FINAL FINDINGS AND DECISION BY THE LANDMARKS COMMISSION RENDERED ON December 12, 2016

**CASE FILE NUMBER: LU 16-207720 HRM AD
PC # 16-134597**

Multnomah County Central Courthouse Project

West Avenue Elevation - Jefferson Station - **Option B**

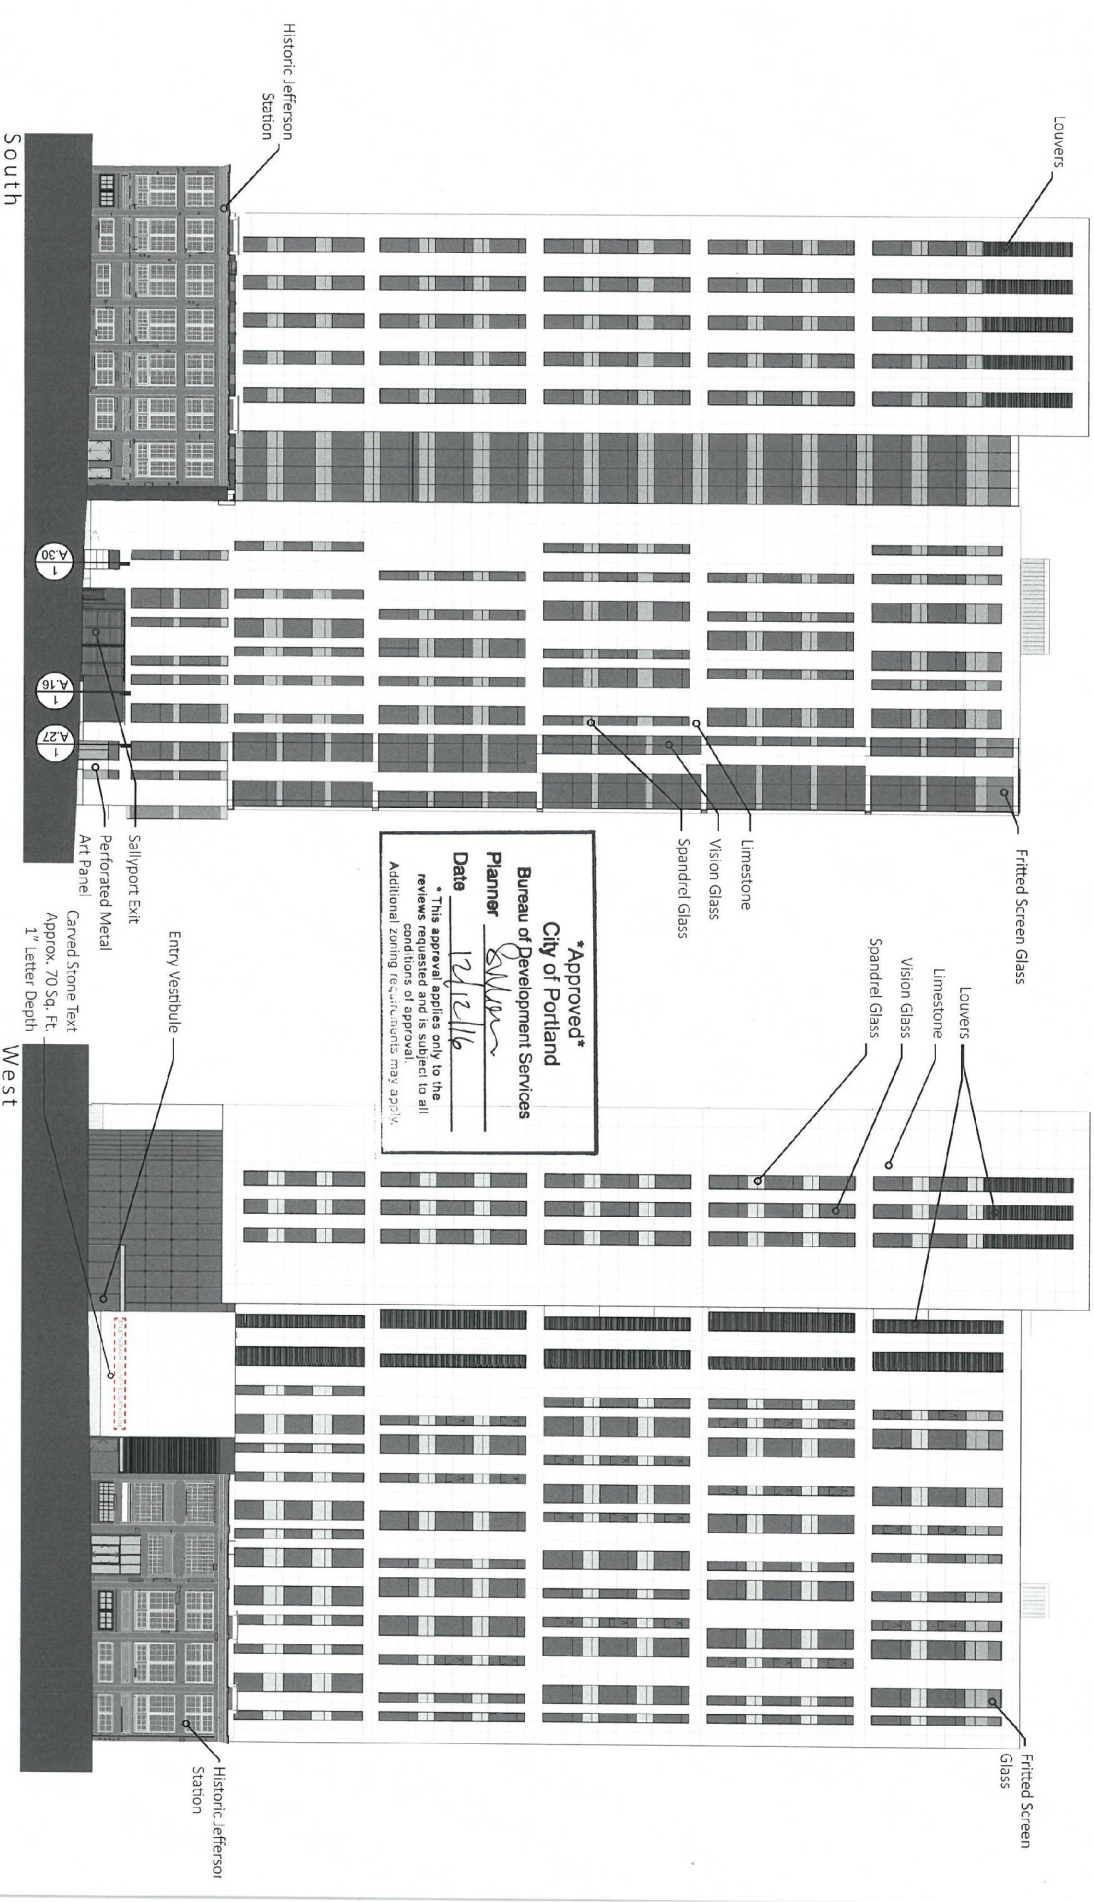
- SW 1st Main Entry – A more compatible and sensitive design of the main entrance has been provided that is in keeping with the scale of the original entry at this location, which included a large pair of wood utility doors with the upper portion glazed with a 3x2 array of divided lites. To increase articulation, the steel frame elements have been replaced with slightly thicker wood framing and the paired doors (8'-6" in height) will be aluminum clad wood. As noted below, a new canopy has also been added. However, since the second floor level exists directly behind the entry, two opaque treatments above the entry doors were presented to the Commission for consideration at the December 12th hearing:

The Commission expressed a preference for Option B, stating the solid wood panel in Option A felt like a heavy element while the glazing in Option A is more indicative of an "opening". However, the Commission concluded the shadow box design was not a typical or common condition on historic buildings and that frosted glass would serve the same purpose and be more appropriate. Therefore, a condition of approval was added to replace the shadow box with frosted glass in Option B.

As revised and with the approval of Option B and a condition to replace the shadow box with frosted glass, these criteria are met.
